Photovolt Development Partners, on behalf of SolarFive Ltd (the Applicant), is carrying out a targeted consultation for Botley West Solar Farm, focusing on one specific change within the Central Site. The change is located on the southern edge of Bladon Heath, south of Bladon and west of Begbroke in the Central Site.

Appendix 1: Map of Change to Order Limit

Appendix 2: Details of Change to Order Limit

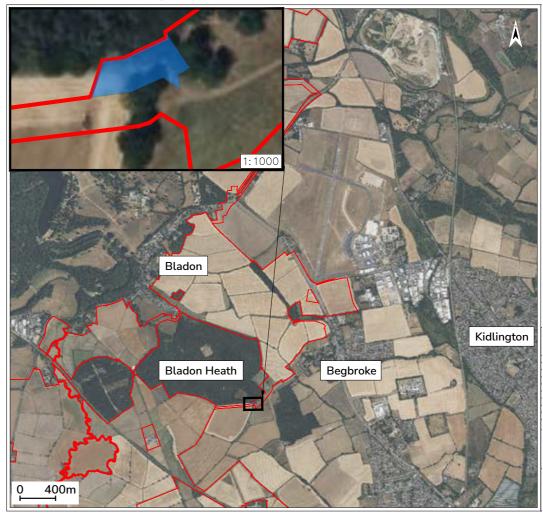
The Order limit is being extended slightly in a targeted area to include additional land around an established veteran tree. The additional land area is shaded blue in the image to the left.

This proposed amendment is to add choice to the proposed cable corridor for the Applicant to avoid or minimise environmental effects upon the veteran tree.

As a result of the extended redline, the Applicant is able to consider two potential alternative cable routes as to where and how the underground electrical cables will be installed. No additional solar panels or above-ground infrastructure are proposed in this area.

The previous proposals had assumed the underground cable would be installed beneath the veteran tree using a technique called Horizontal Directional Drilling (HDD). The Applicant is now proposing to include this additional land to also allow for the option for cables to be installed to the north of the tree, using cut and cover methods, should that be considered preferable in environmental and engineering terms. Further assessment work will be undertaken to inform this choice.
